RE: City of Kirkland / Watershed Company review comments for 9757 (9900) 124<sup>th</sup> Avenue NE.

This letter and the accompanying Buffer Mitigation Plan for Cedarbrook Short Plat prepared by *Acre Environmental Consulting, LLC* and dated September 30, 2013 Revision #1 are intended to provide the additional information requested by the Watershed Company in their September 25, 2013 comment letter for the above site (Watershed Company Reference Number: 100714.17). The recommendations provided by the Watershed Company in their comment letter are included below in bold italics and descriptions of how the recommendations were addressed are in plain text.

**BUFFER MITIGATION PLAN**  
**CEDARBROOK SP**  
9757 124TH AVENUE NE  
KIRKLAND, WA 98033  
TAX PARCEL NO.: 123850-0890

**SHEET W-1**

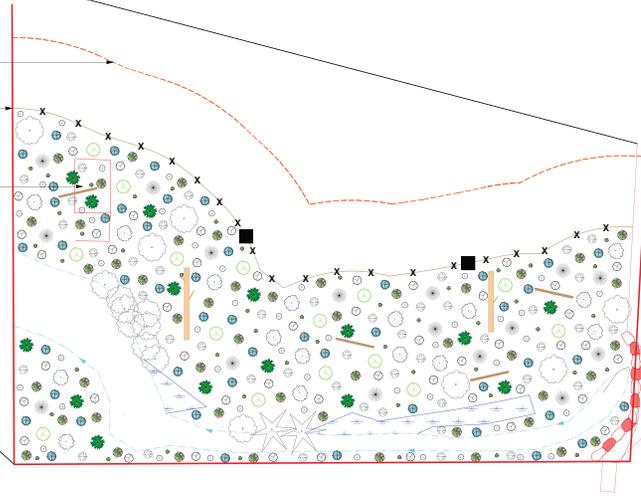
**9. Add the split rail fence and signage to the work sequence and provide a detail drawing.**

Installation of the split rail fence and signs has been addressed in the *Buffer Enhancement* section of the Buffer Mitigation Plan for Cedarbrook Short Plat prepared by *Acre Environmental Consulting, LLC* and dated Revision 1, September 30, 2013. Detail drawings for both the fence and signs have been provided on Sheet W-1 of the above plan.

Following installation of the above mitigation plantings, a split rail fence shall be installed along the perimeter of the 50-foot reduced buffer as depicted on this plan. A total of two Environmentally Sensitive Areas (ESAs) shall be affixed to this fence in the locations shown on this plan (fence and sign details are included on this sheet).
